1. Product type: Front Load washing machine
2. LG Model / Buyer Model: Refer to the model list on pages 2 & 3.
3. Applicable Serial No: 806KWxxx and later
4. Effective Date: 21 Aug, 2008

Subject: New hinge assembly and cabinet front panel are applied to all products

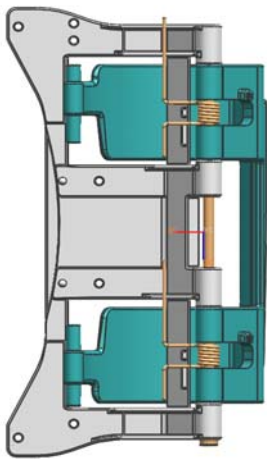
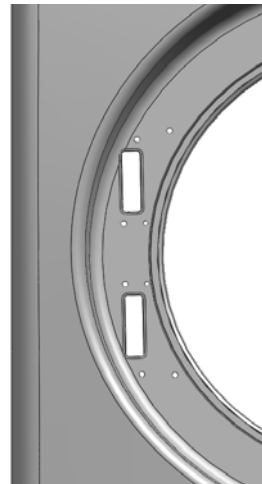
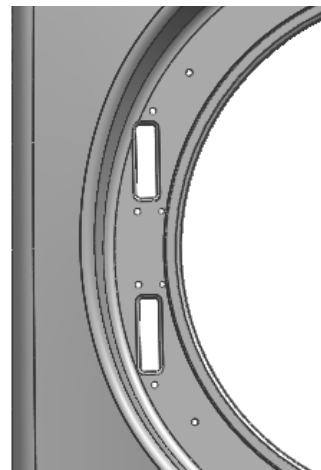
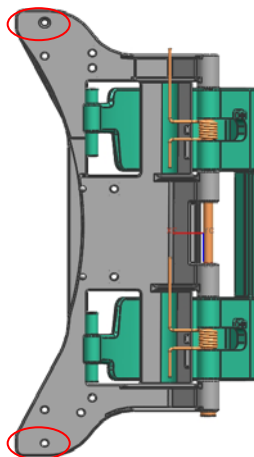
which were manufactured after June 1, 2008. **The size and shape of the new hinges was changed to increase the strength and durability of the hinges. Due to a change in the mounting screw configuration, the new hinges will not fit on the old front panel. If the front panel is to be replaced, a new style hinge will also need to be ordered.**

Will not work

Recommended Combinations		Cabinet front panel (old)	Cabinet front panel (new)
Hinge P/NO: 4775ER2002	Hinge (old)	OK	Will not work
	Hinge (new)	OK	OK

1. If you only need to change the hinge assembly, the new style hinge assembly can be used as a direct replacement. The new style hinge assembly can be used with either the old or the new style front panel.

2. Because the old style hinge assembly does not properly fit the new style cabinet front panel, it will be necessary to replace the hinge assembly when replacing the cabinet front panel on products built prior to June 1, 2008.
